# **CHIPPENHAM WITHOUT PARISH COUNCIL**

## **STATEMENT OFH2 Tuesday 30 June 2026**

### **LIME DOWN SOLAR PARK – EN010168**

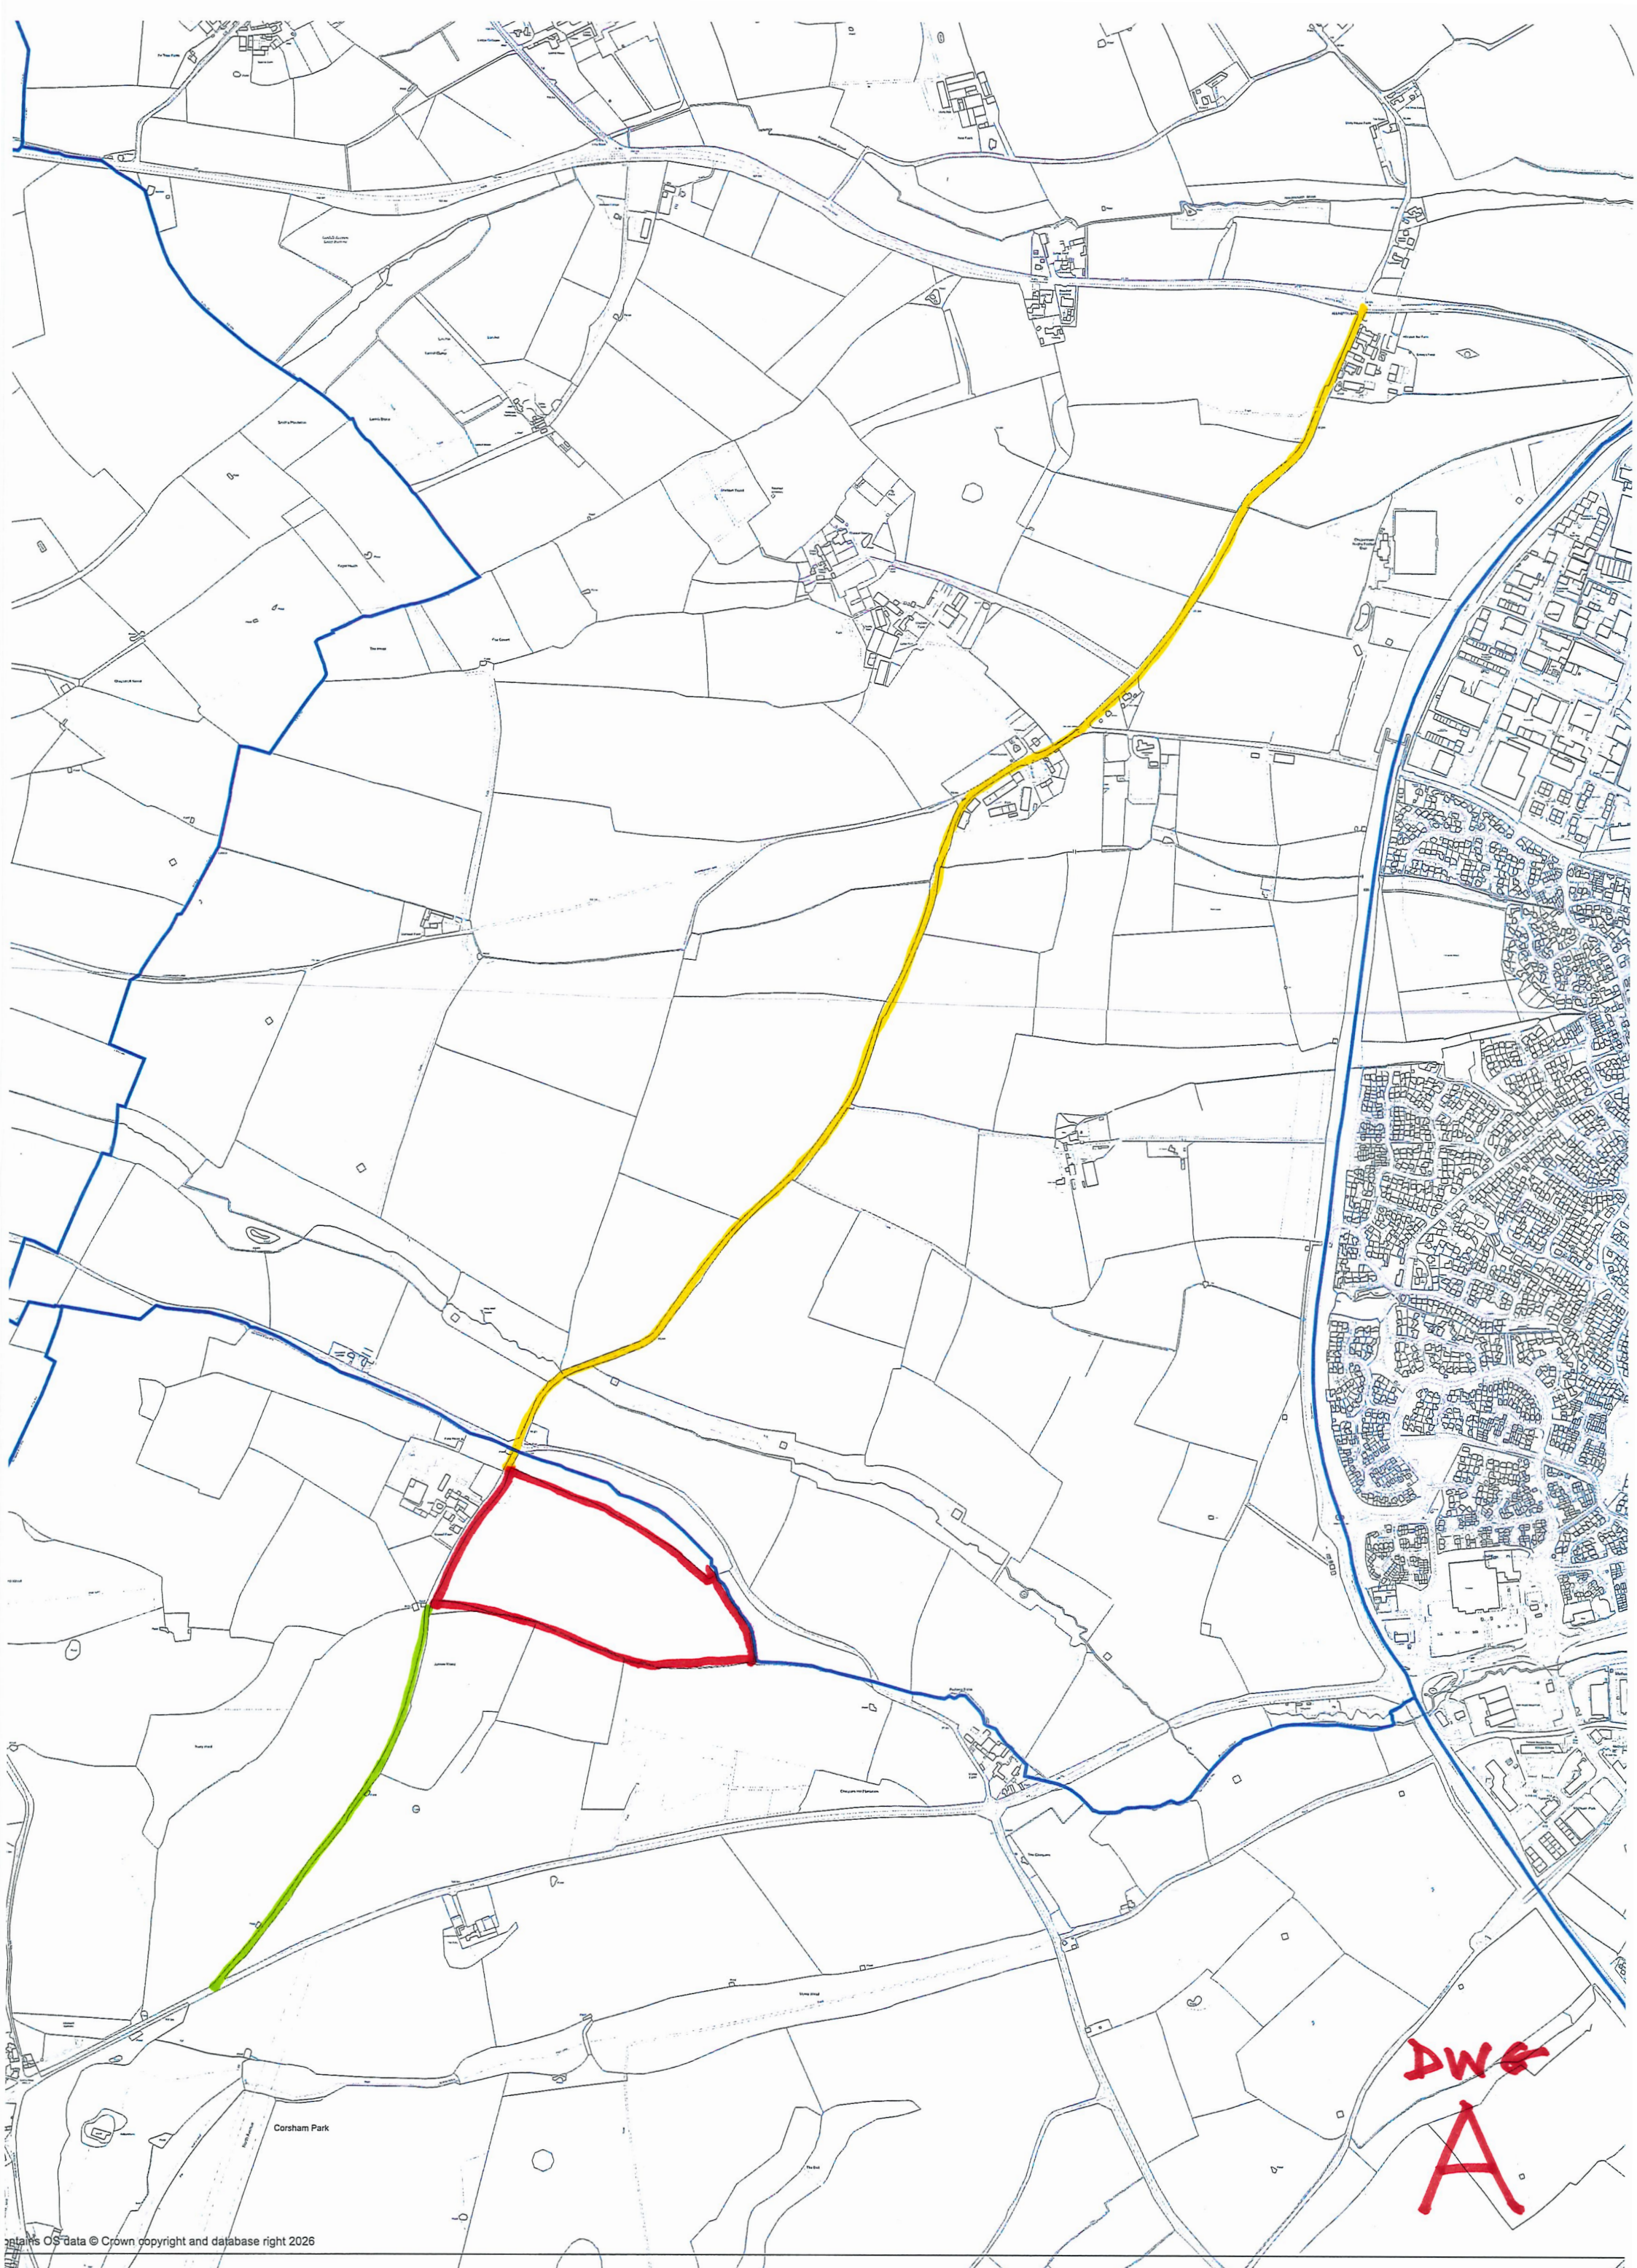
One site is within the Parish in the field bordered by Fowlswick Lane and the B4039, the through route from the A420 to Yatton Keynell, with the Golf Driving Range to the North. (DWG. B supplied identifies this)

Access to this field is proposed from Fowlswick Lane about 200 metres from the existing crossroads. The proposed opening serving an access track will require considerable enlargement and metaling, as will the Fowlswick Lane itself, which would need to be widened down to the crossroads. (Identified yellow on DWG. B)

This will potentially require the removal of the mature hedgerow along the 200 metre length with verge and also have highway drainage implications. The existing crossroads is a known accident black spot and is far from ideal for use by plant and heavy vehicles.

The other potential access to this field is proposed to be directly onto the B4039, on the western boundary of the field, which is also a traffic hazard and which will require a large splayed access, with significant visibility splays and signage and a reduction in speed limit. (Identified green on DWG. B)

It is considered that if either access proposal was adopted the entire length of mature hedgerow on the B4039 in the northern direction would need removal and replaced along a new visibility line to the crossroads. The change in landscape of this rural area required by these works to facilitate a safe highway arrangement would have significant detrimental impact on the overall character of the area.
